Access Compliance Report

Public Rights-of-Way

| Intersection ID: 10028782 | Main Street: HUNTINGTOWNE_FARMS_LN | Cross Street: N/A | Location: SW |
| ADA ID: B5F5F244CC17 | Ramp Type: Perp | Initial Pass/Fail: Fail | Overall Compliance: No |

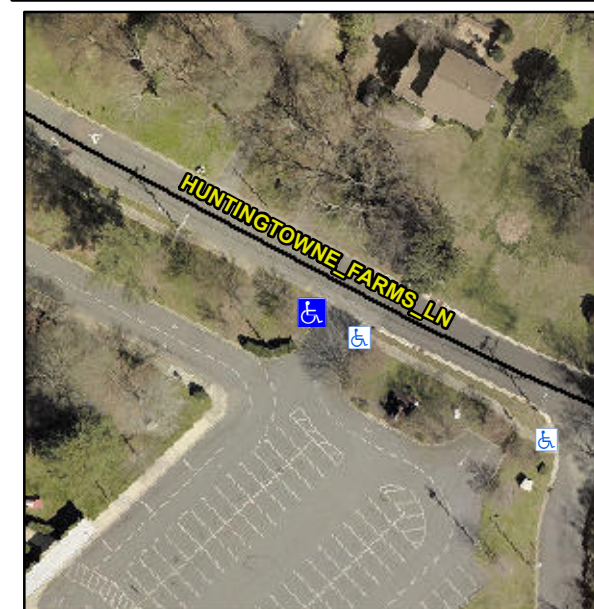
R304.2.2, R304.5.3

| Compliance | Description | Data | Compliance | Description | Data |
|------------|-----------------------|-------|------------|-----------------------------|------|
| N/A | Ramp Length (in) | 73.0 | No | Ramp Slope (%) | 12.3 |
| Yes | Ramp Width (in) | 48.0 | No | Ramp XSlope (%) | 4.1 |

Remove & Replace Entire Ramp.
